UNITED STATES PATENT AND TRADEMARK OFFICE

APPLICATION NO.	FILING DATE	FIRST NAMED INVENTOR	ATTORNEY DOCKET NO.	CONFIRMATION NO.
10/707,184	11/25/2003	Peter T. Kazlas	H-360	1183
26245	7590	11/20/2006	EXAMINER	
DAVID J COLE E INK CORPORATION 733 CONCORD AVE CAMBRIDGE, MA 02138-1002			NGUYEN, KHIEM D	
			ART UNIT	PAPER NUMBER
			2823

Office Action Summary	Application No. 10/707,184	Applicant(s) KAZLAS ET AL.	
	Examiner Khiem D. Nguyen	Art Unit 2823

Fig. 16

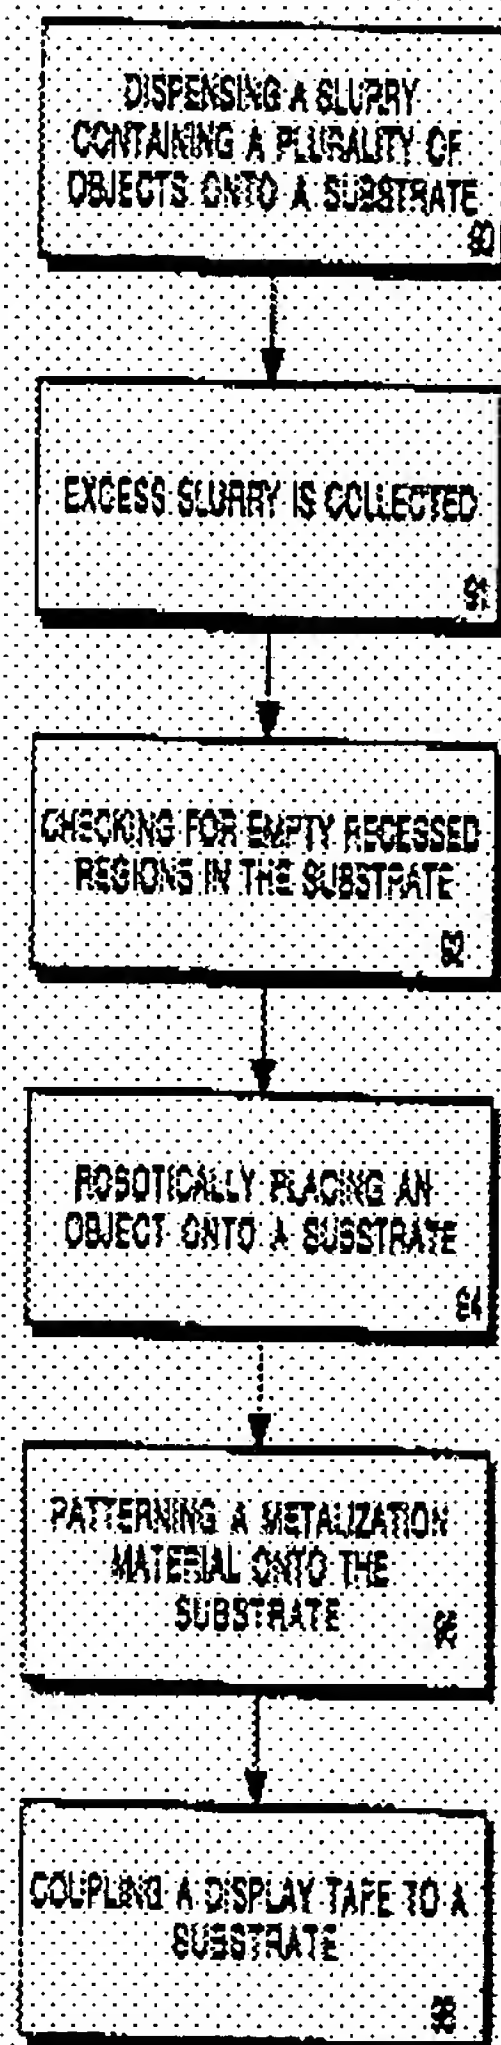
In re claim 1, **Jacobsen** discloses a backplane for use in an electro-optic display, the backplane comprising a patterned metal foil (FIG. 16, step 96) having a plurality of apertures extending therethrough (col. 11, lines 13-38), coated on at least one side with an insulating polymeric material (FIG. 16, step 98) and having a plurality of thin film electronic devices provided on the insulating polymeric material (col. 10, lines 56-67 and FIG. 17, step 430).

In re claim 12, Jacobsen discloses a backplane for use in an electro-optic display, the backplane comprising a metal foil (FIG. 16, step 96) coated on at least one side with an insulating polymeric material (FIG. 16, step 98) and having a plurality of thin film electronic devices provided on the insulating polymeric material (col. 10, lines 56-67 and

FIG. 17, step 430), the backplane further comprising at least one conductive via extending through the polymeric material (col. 11, lines 13-38) and electrically connecting at least one of the thin film electronic devices to the metal foil.

Fig. 16

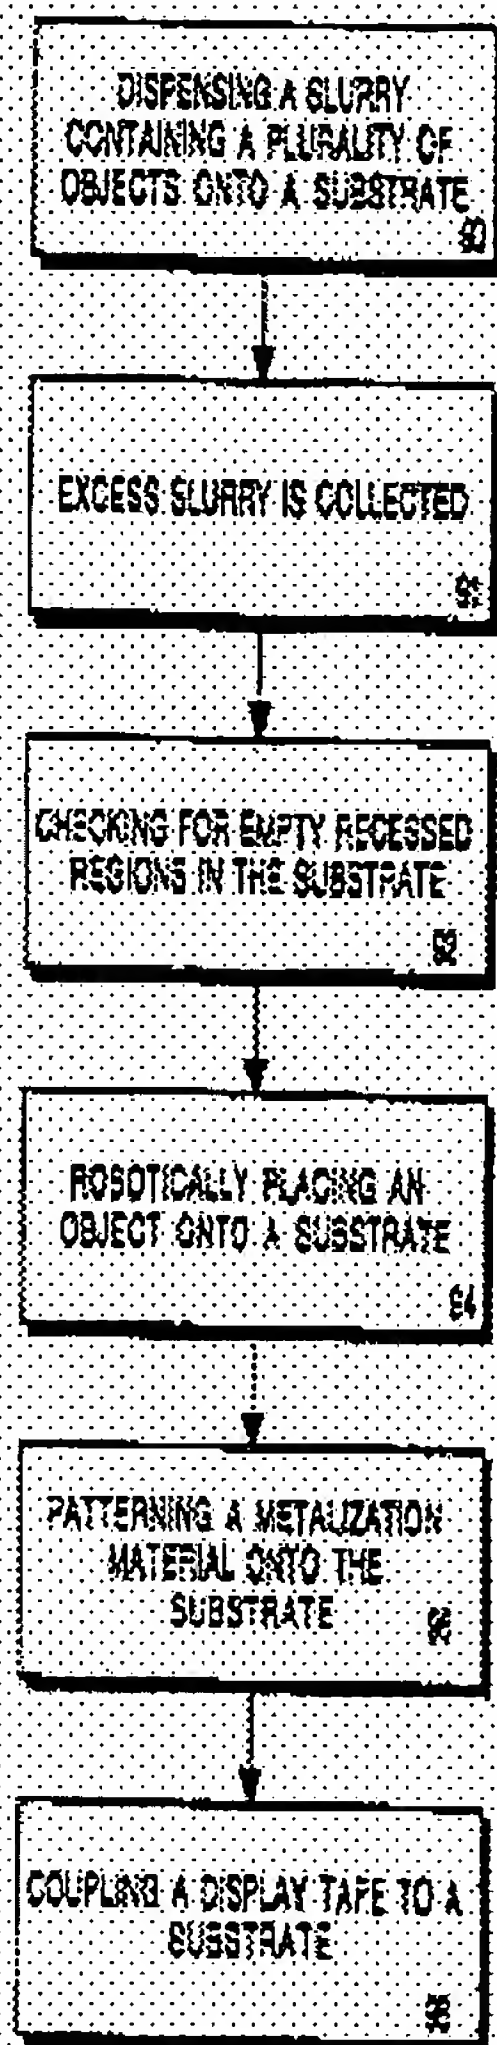
In re claim 24, Jacobsen discloses an electro-optic display having a metal substrate (FIG. 16, step 96), the display having a central portion comprising an electro-optic material and means for writing an image on the electro-optic material, and a peripheral portion extending around at least part of the periphery of the central portion, the peripheral portion having a plurality of apertures (col. 11, lines 13-38) extending through the metal substrate, by means of which apertures the electro-optic display may be stitched to a flexible medium (col. 10, lines 56-67 and FIG. 17, step 430).

In re claims 3 and 4, as applied to claim 1 Paragraph 3 above, Jacobsen discloses all the claimed limitations including a backplane comprising a patterned metal foil (FIG. 16, step 96) having a plurality of apertures extending therethrough, wherein the apertures occupying a certain predetermined percentage area of the patterned metal foil (col. 11, lines 13-38) but does not explicitly teach or suggest wherein the apertures occupy at least about 30 percent or 60 percent of the area of the patterned metal foil.
